**SUBJECT: MODEL 230.474/475/476/479
MODEL YEAR 2005
CELLULAR TELEPHONE/VOICE CONTROL SYSTEM INSTALLATION**

2018 DIY GENERAL NOTES

Figure 3

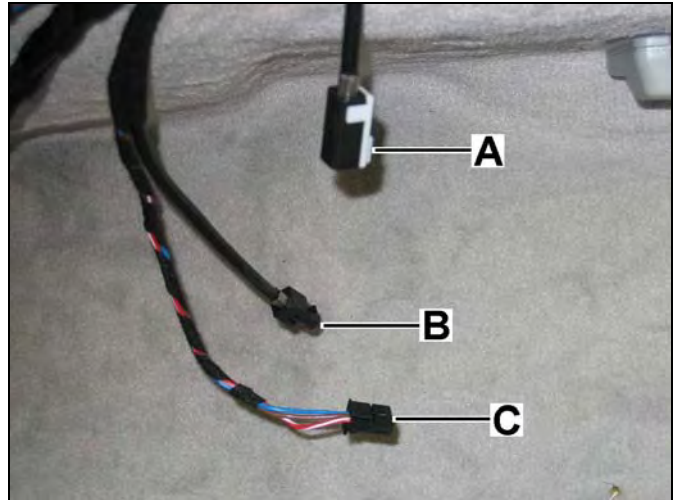
3. Among the cable connectors removed from the cloth sock, find the:
 - **NOT USED** Female, black FAKRA antenna lead (A, Figure 3)
 - Male, black FAKRA **TELEPHONE** antenna lead (B, Figure 3)
 - Linear compensator power supply connector (C, Figure 3)

Figure 5

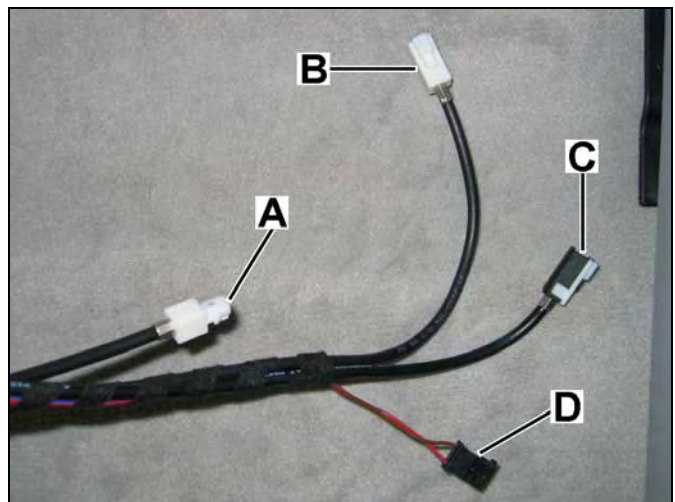
5. Among the cable connectors removed from the cloth sock, find the:
 - **NOT USED** Male, white FAKRA main antenna lead (disconnected in step 4) (A, Figure 5)
 - Female, white FAKRA **ANTENNA** Tele Aid lead (disconnected in step 4) (B, Figure 5)
 - **NOT USED** Female, black FAKRA telephone lead (C, Figure 5)
 - **NOT USED** Antenna switch 2-pin power supply connector (D, Figure 5)

Figure 6

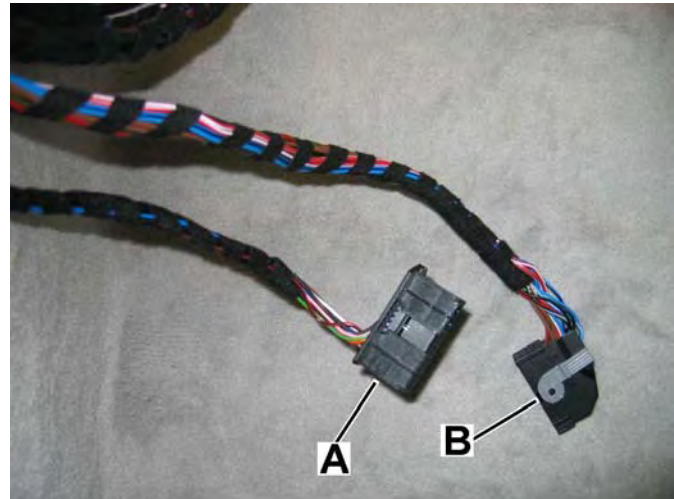
- **NOT USED** VCS power supply connector

- MHI power supply connector (B, Figure 6)
- Remove the locking tab by sliding it and pull connector out (Figure 6.A and 6.B)
- Check pin locations 11, 12, 29, 30, 31 and 32. If they have wires of color Black (thick), Grey, Pink, Violet, Green, Orange, in this order, then go to paragraph C.

Figure 6.H

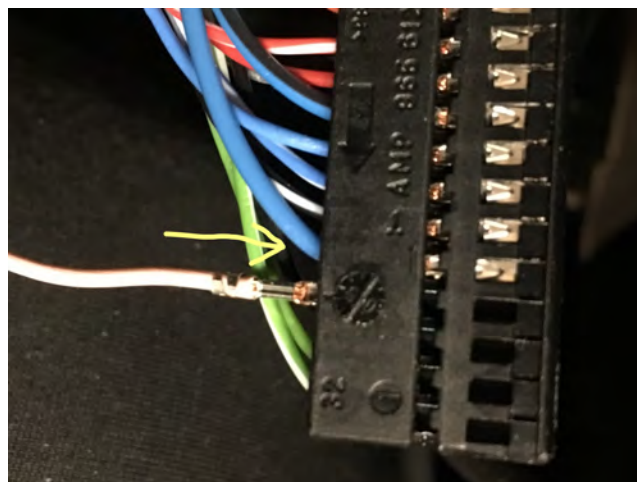
- These wires are in the VCS connector (Figure 6.C)
- Lift the locking latch on the side and slide the connector out from the shell (Figure 6.D and 6.E).
- To remove the wires from connector, press the triangle in Figure 6.F while pulling the wire. It may need to be pressed again as it moves to the next opening (Figure 6.G).
- Remove about 1 ft. of the cloth electrical tape from the VCS cable, separate the shielded cable containing the released wires and bundle it with the M/UHI cable using the removed cloth tape.
- push the wires into the empty locations in the M/UHI connector per below (Figure 6.H):

COLOR	FROM VCS LOCATION	TO M/UHI LOCATION
BLACK (THICK)	16	11
GREY	14	12
ORANGE	6	32
GREEN	5	31
VIOLET	15	30
PINK	4	29

Figure 8

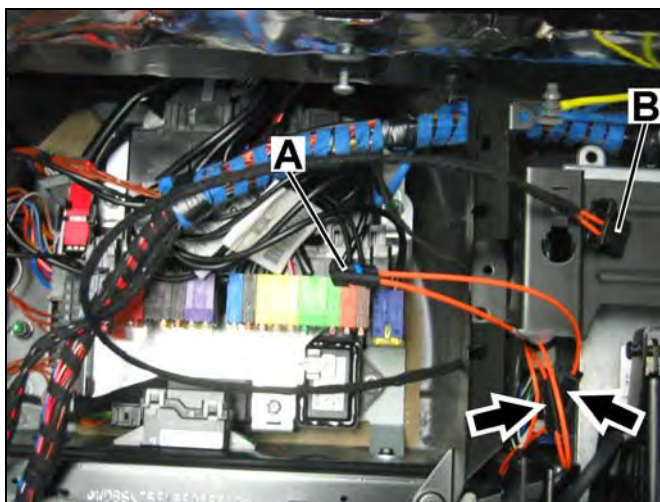
2. Cut the wire tie (A, Figure 7), and remove the tape bundling the MOST fiber and coupler.
3. Disassemble the MOST coupler and carefully remove the fiber ends (Arrow, Figure 7).
4. **INSERT THE FIBER ENDS INTO THE PURCHASED MALE CONNECTOR.** Install the kit-included MOST adapter cable (Arrows, Figure 8).
 - a. Connect the fiber end of the MOST adapter cable to the MOST coupler disassembled in step 3 and then reassemble the coupler.
 - b. Connect the fiber end removed from the MOST coupler disassembled in step 3 to the coupler of the MOST adapter cable.

Figure 11

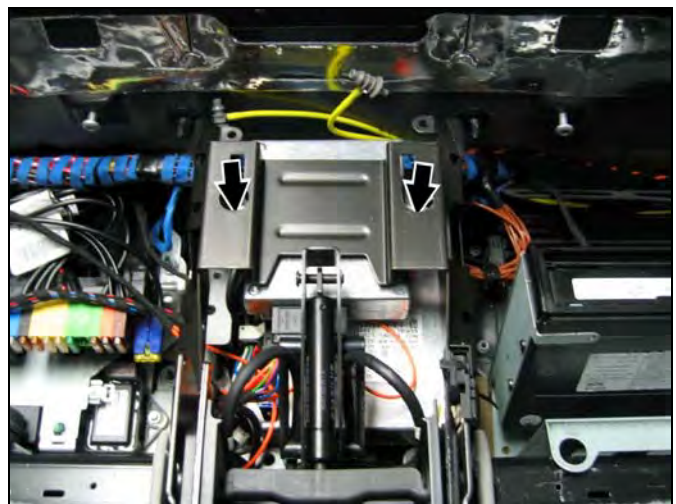
8. With **MHI** VCS power supply/MOST connector **TO THE RIGHT** facing front and mounting tabs facing up, carefully slide the **MHI** VCS control module under the console bracket and **CONNECT THE OPTICAL AND POWER CONNECTORS**. fasten its mounting tabs to the bracket with two kit-included T15 Torx self-tapping screws and washers (Figure 11).

Figure 13

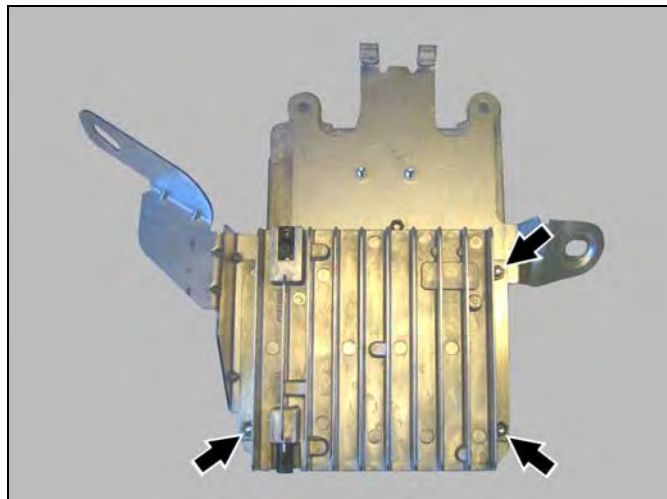
2. Fasten the linear compensator to the **IN A SUITABLE LOCATION USING TIE WRAPS.** threaded studs on the bracket backside with three M3 nuts (Figure 13).

Figure 16

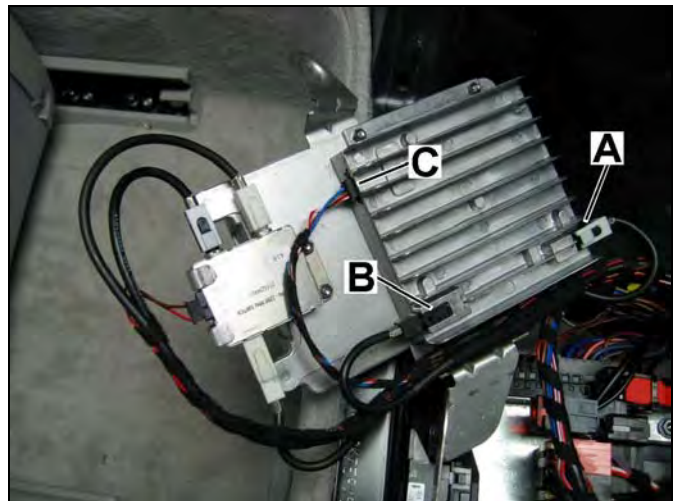
9. Connect the FAKRA antenna male, black connector to the linear compensator jack labeled "PORTABLE" (A, Figure 16).
10. Connect the FAKRA antenna female, **WHITE** black connector to the linear compensator jack labeled "ANTENNA" (B, Figure 16).
11. Connect the power supply connector to the linear compensator (C, Figure 16).

Figure 29

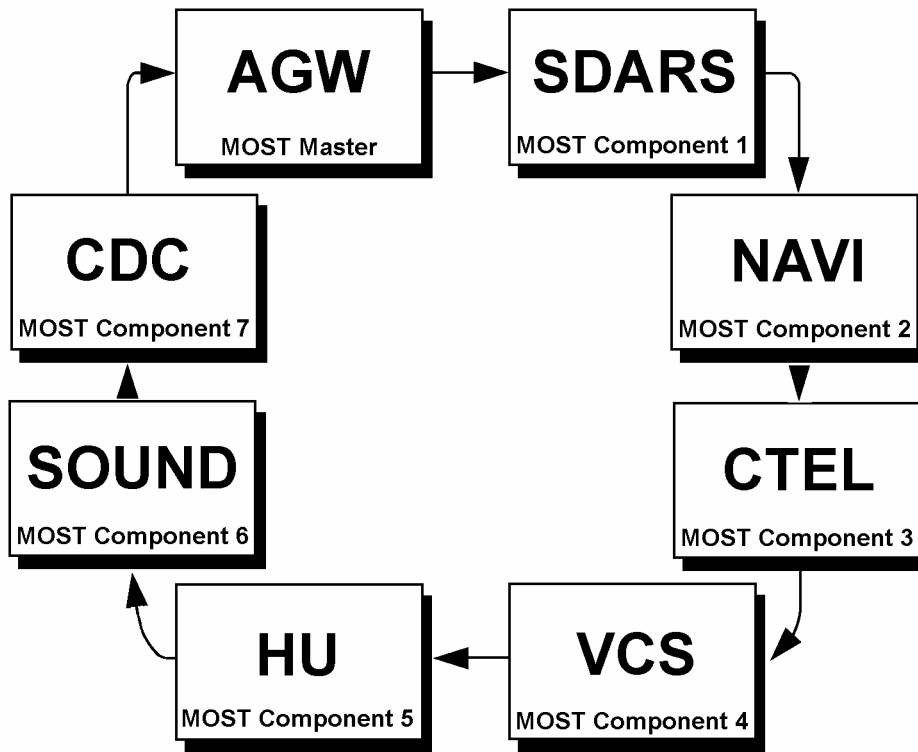
3. **IF OPTICAL RING SHOWS ERROR/INTERRUPTION CHANGE THE LOCATION OF THE 2 FIBER ENDS INTO THE MALE CONNECTOR AT STEP C4**
Note: The MOST ring configuration in Figure 29 is an example of a configuration including every component. Some installations will not include all the components shown in the example. If a component is not present, connect the preceding component to the component following the one not present.
NOTICE!
DO NOT alter the configuration in Figure 29 to match the vehicle configuration. Failure to have the configuration match Figure 29 will result in erroneous system operation and/or intermittent malfunctioning of some or all components.
